3Foxes Biodiversity Solutions
23 De Villiers Road
Kommetjie
7975
24 February 2025

RE: Part 2 Amendment Application with Regards to Layout Changes to the Beaufort West Solar PV Energy Facility located in in the Western Cape near to Beaufort West

Figure 2. Amended layout of the Beaufort West SEF, showing the final preferred alternative and development areas.

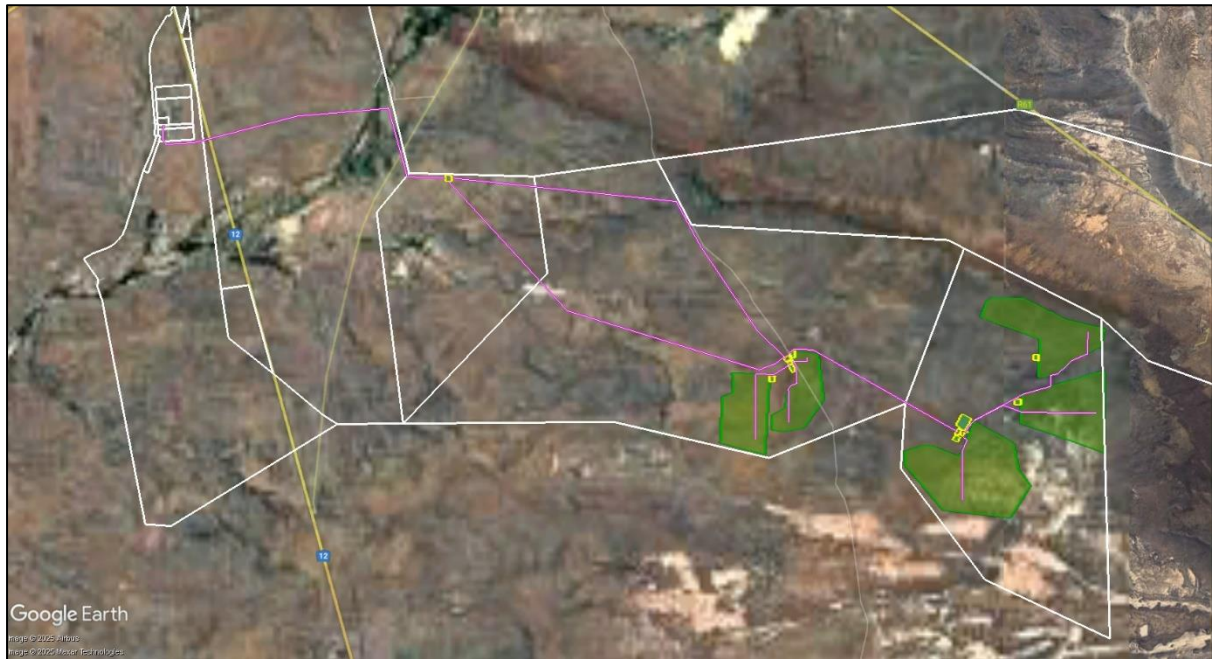
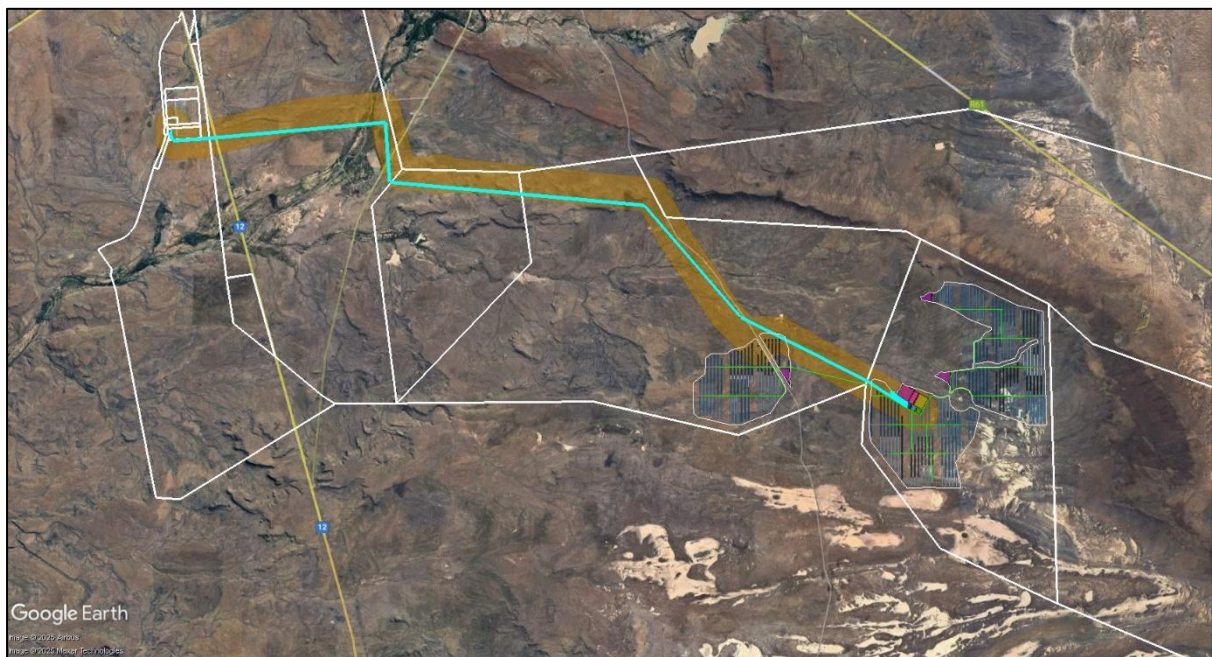
In terms of the Terrestrial Biodiversity Assessment, a full assessment was conducted and the significance of the impacts assessed for the PV facility are provided below. There are no changes in impact significance resulting from the changes associated with the amendment. The amended layout (both the preferred and alternative layout) is not significantly different in location or overall footprint as compared to the original assessment and as such, the original assessment is considered applicable to the current amended layout as well.

The changes to the layout would not entail any significant ecological advantages or disadvantages for the development, for terrestrial fauna, flora or overall terrestrial biodiversity. There are no significant advantages or disadvantages of the changes that would affect the impacts of the development as assessed. As such, the Preferred Layout is considered to be similar to the Alternative Layout in terms of ecological impact and the current Preferred Layout is therefore considered acceptable.

The changes to the layout are within the original assessed development footprint and would not result in any new, novel or increased impacts. As such, there are no additional changes to the mitigation and avoidance measures that were recommended in the original studies. In addition, the cumulative impacts associated with the amendment are considered to be the same as those as assessed and thus there would no changes to the overall cumulative impacts associated with the changes. All of the

The amended layout of the Beaufort West Solar PV Energy Facility development would not generate any novel impacts or increase the severity of existing impacts associated with the SEF, for flora, fauna and overall terrestrial ecology. No additional mitigation or avoidance measures, beyond those already recommended in the EIA study are required for the amendment. As such, there are no reasons to oppose the proposed amendment and it can therefore be supported from an ecological point of view.
